ADDENDUM NO. 2

February 9, 2026

Southport High School Addition & Renovation Phase 1 (Activity Center Addition & Wrestling/Center Plant Renovation)
971 E. Banta Road
Indianapolis, IN 46227

LOAD MAPS

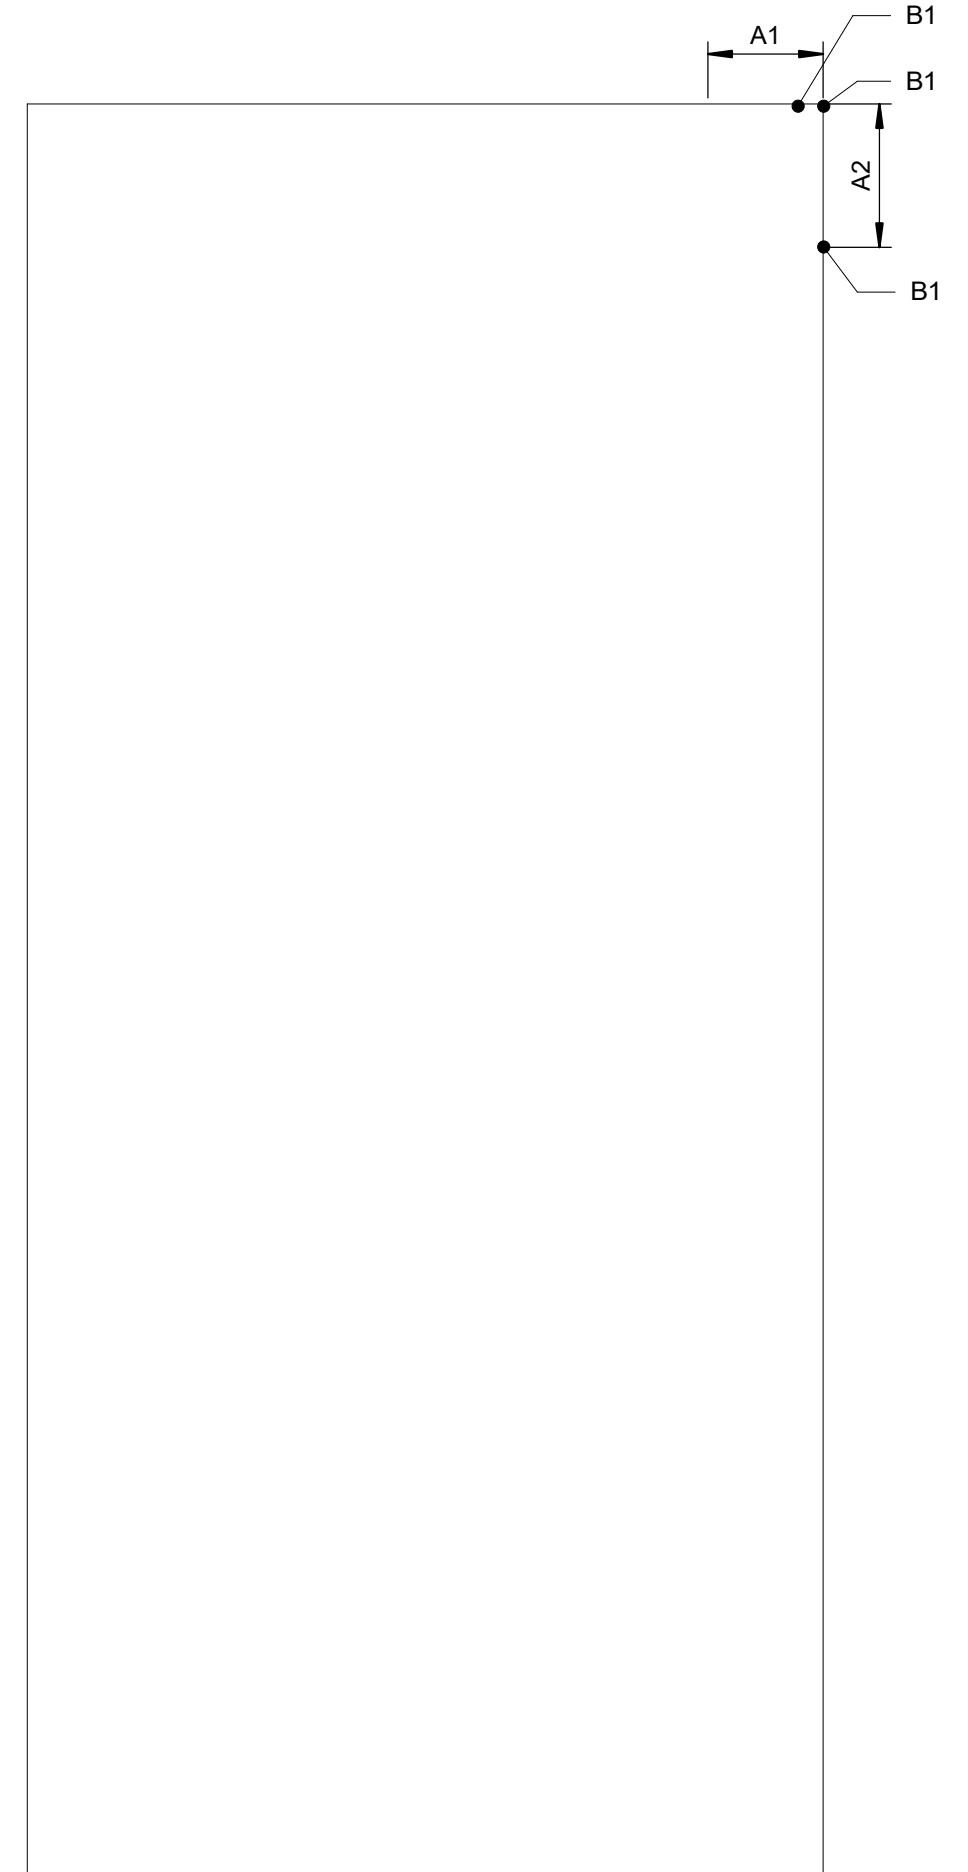
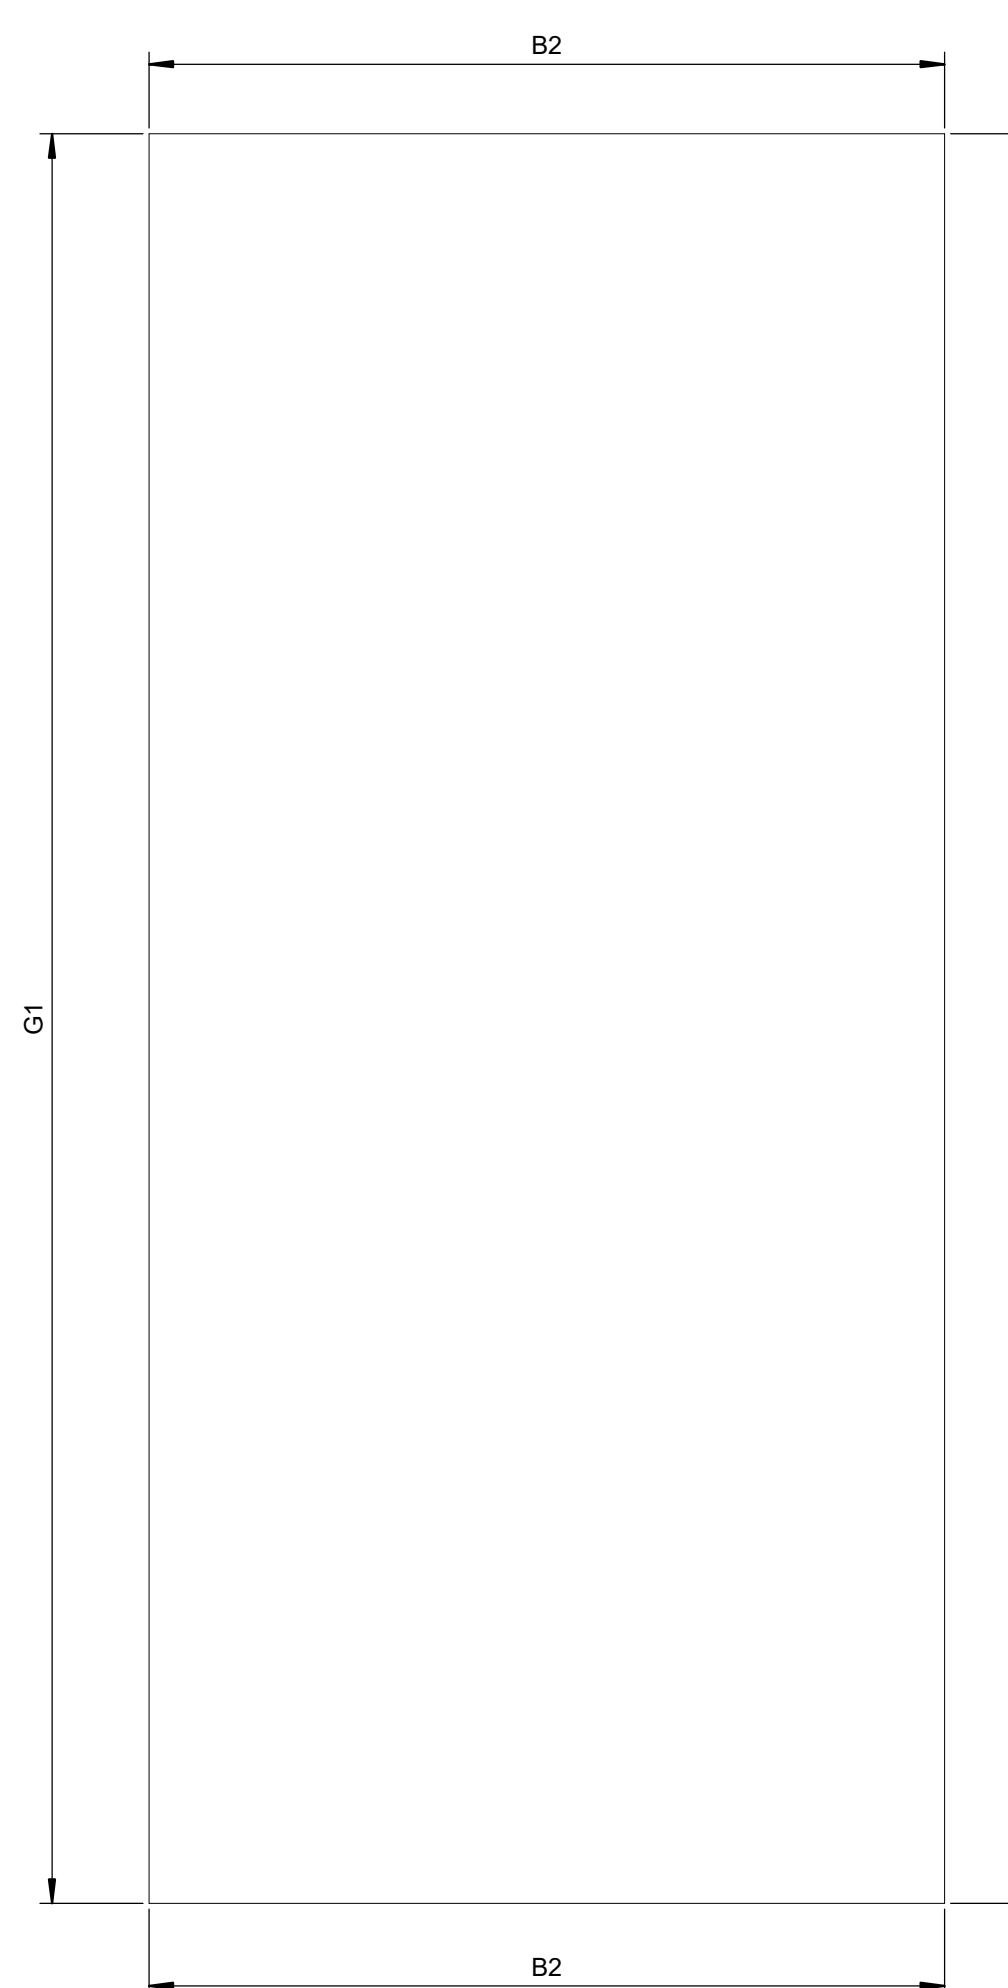
Change: Added note at steel bearing 3.

- Added note regarding roof trusses bracing precast panel.

UNIT S ROOF
FRAMING PLAN

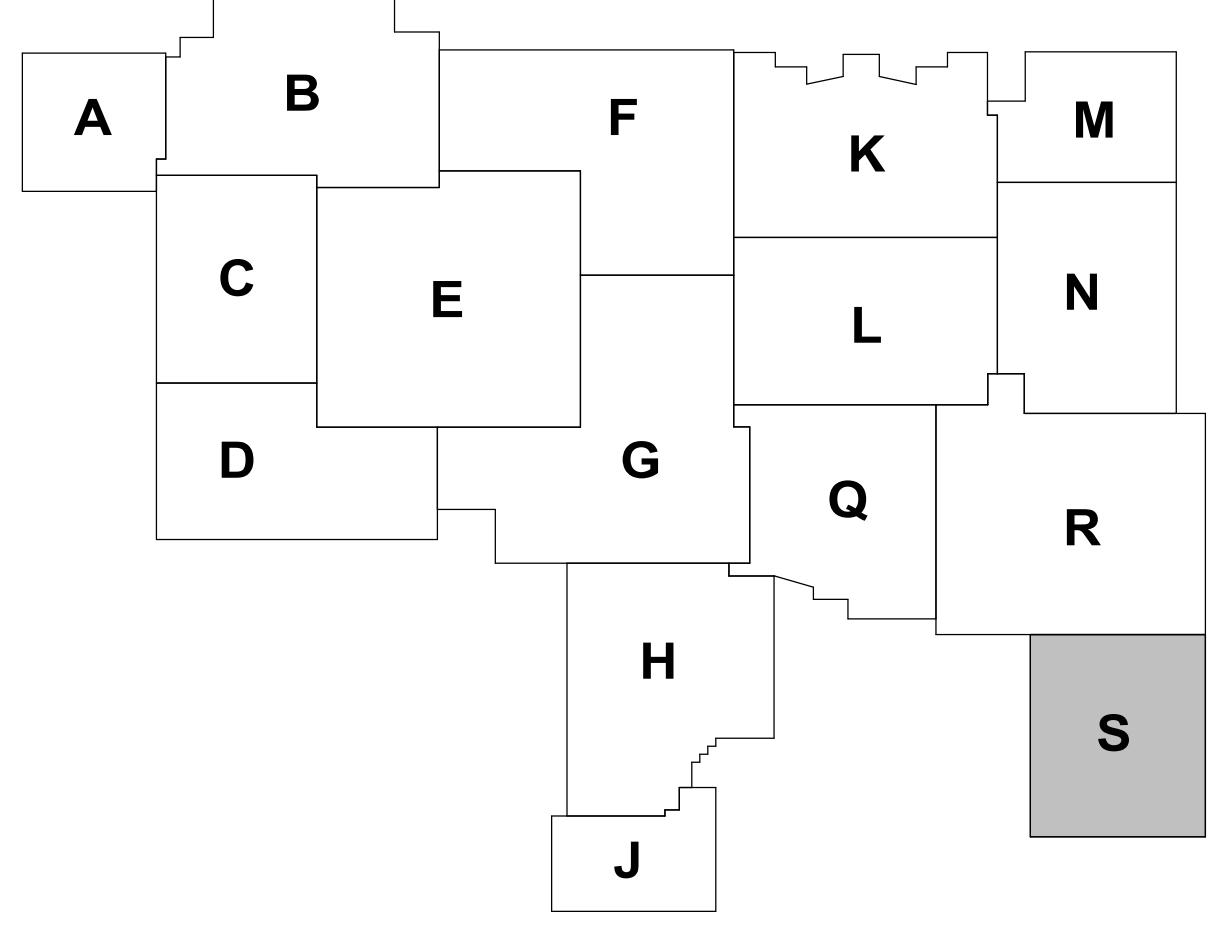
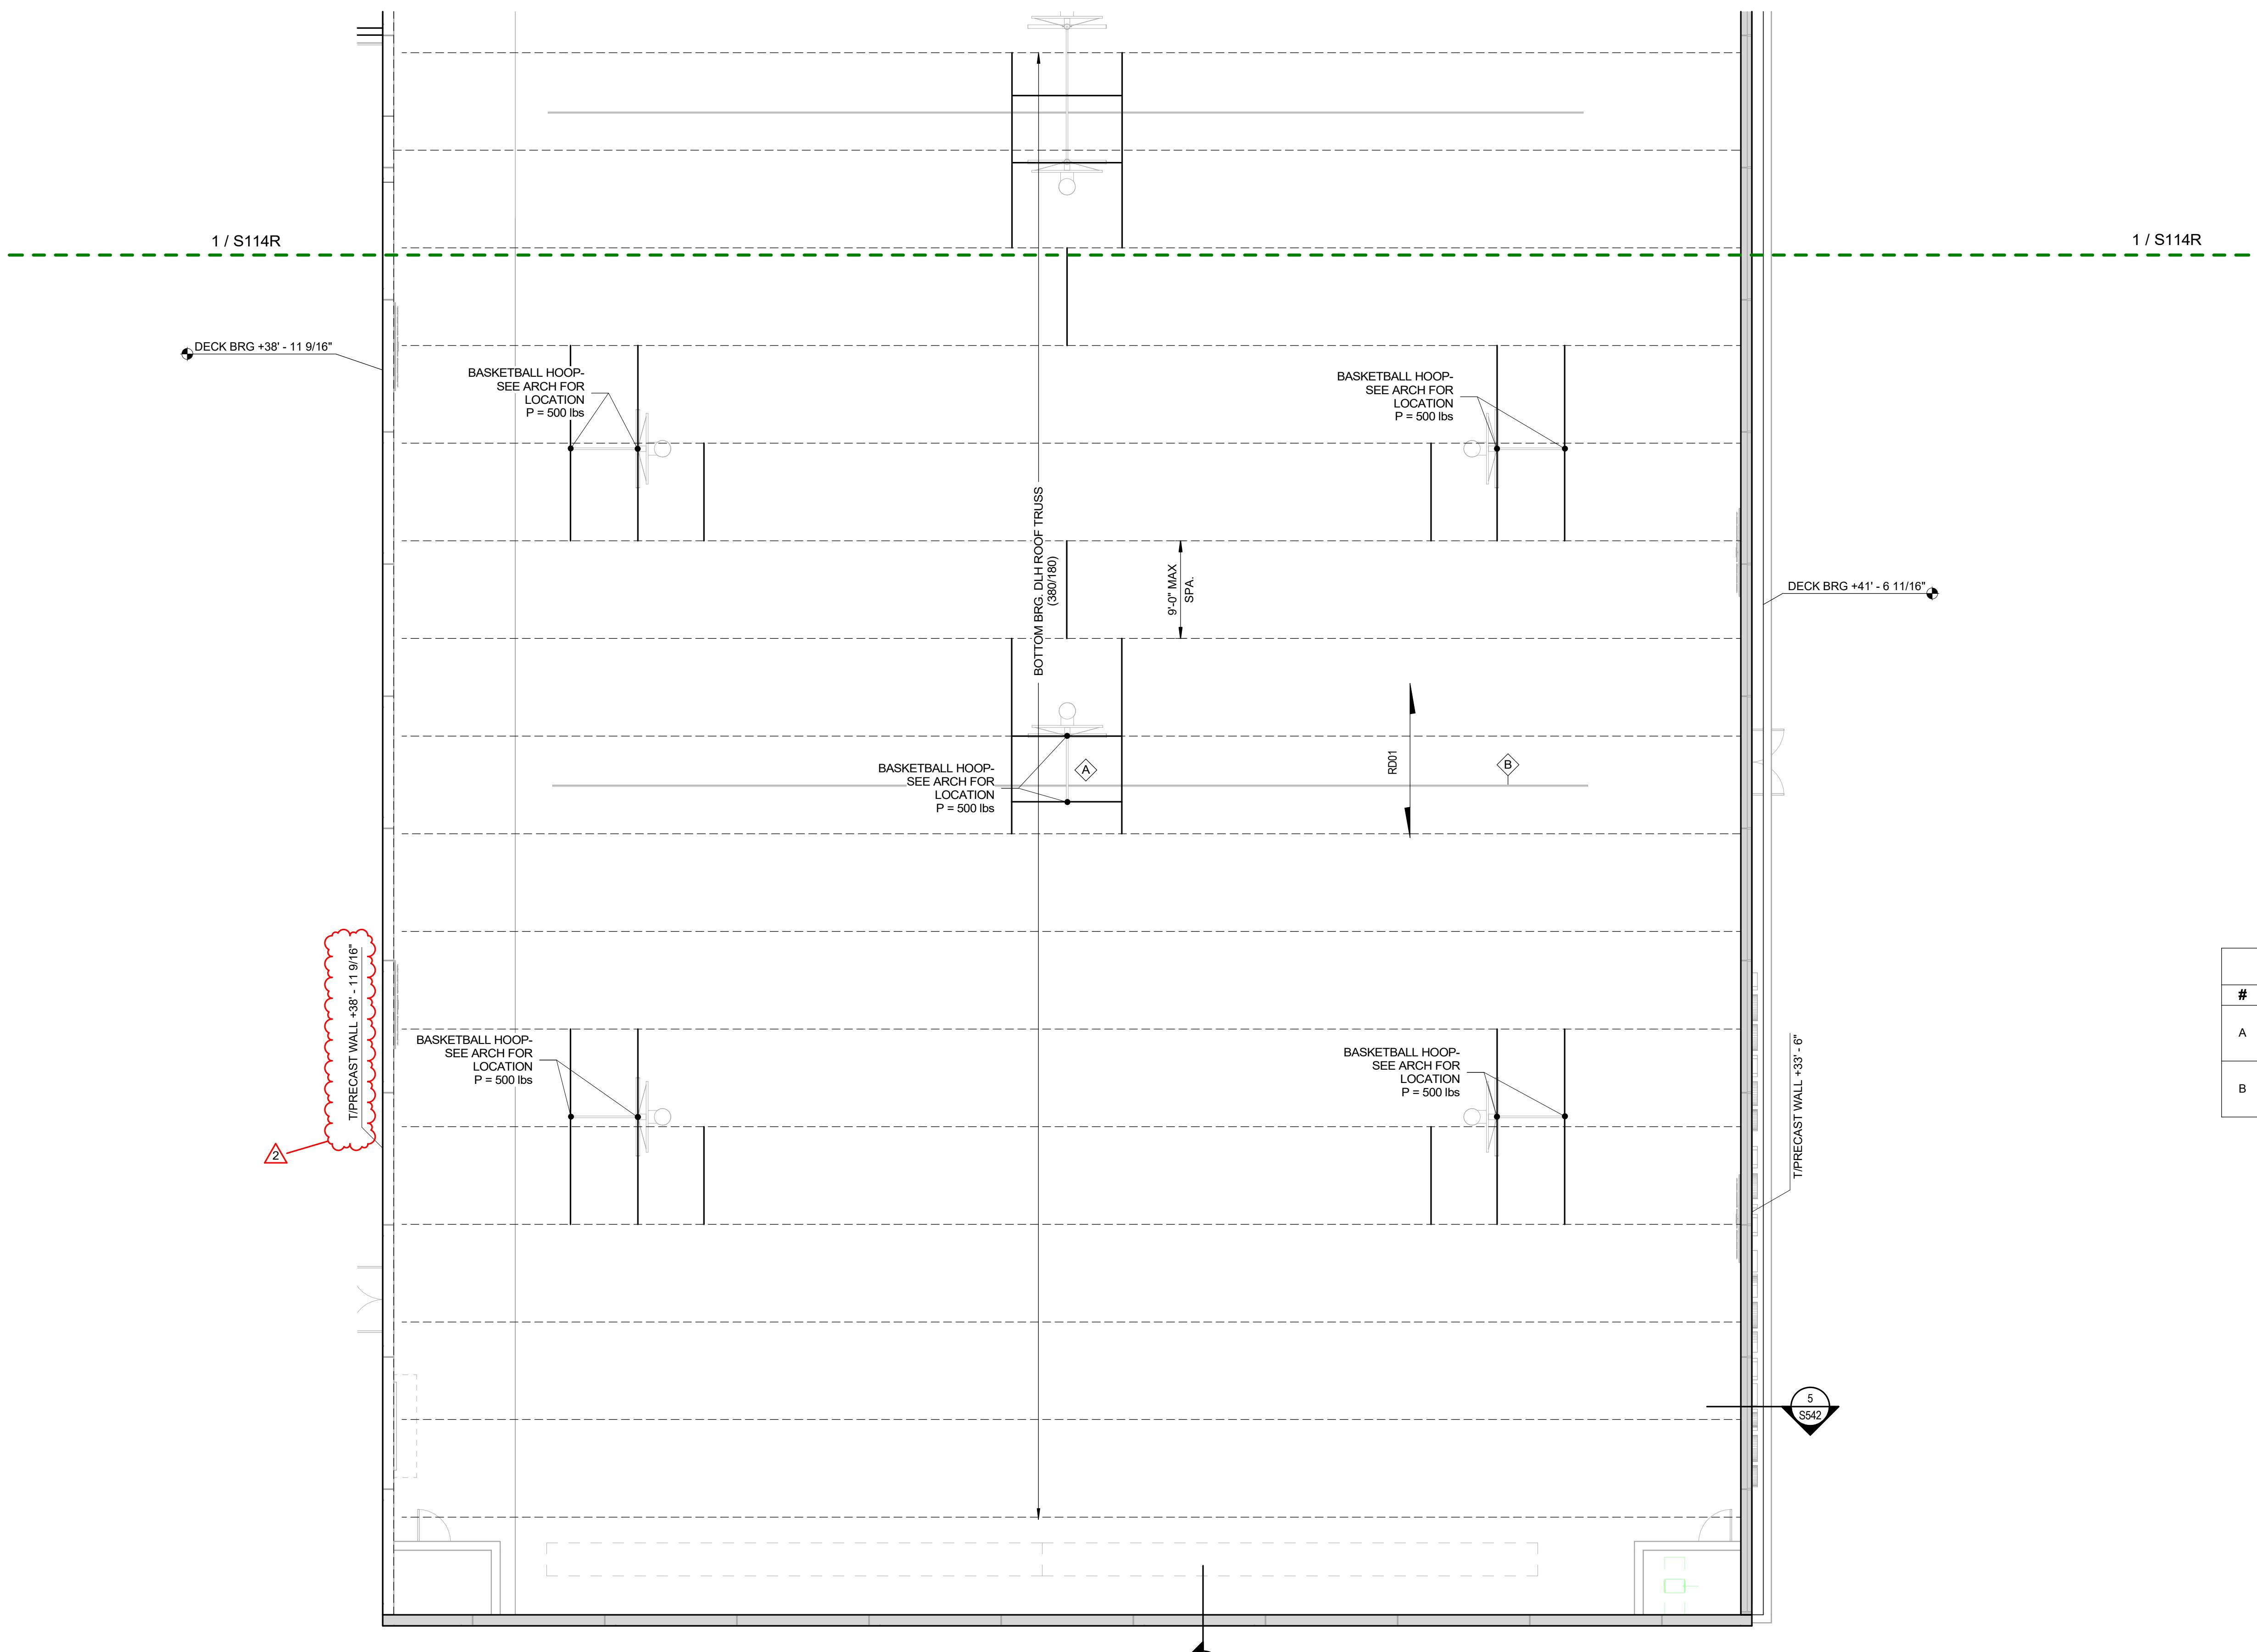
Change: Updated plan dims.
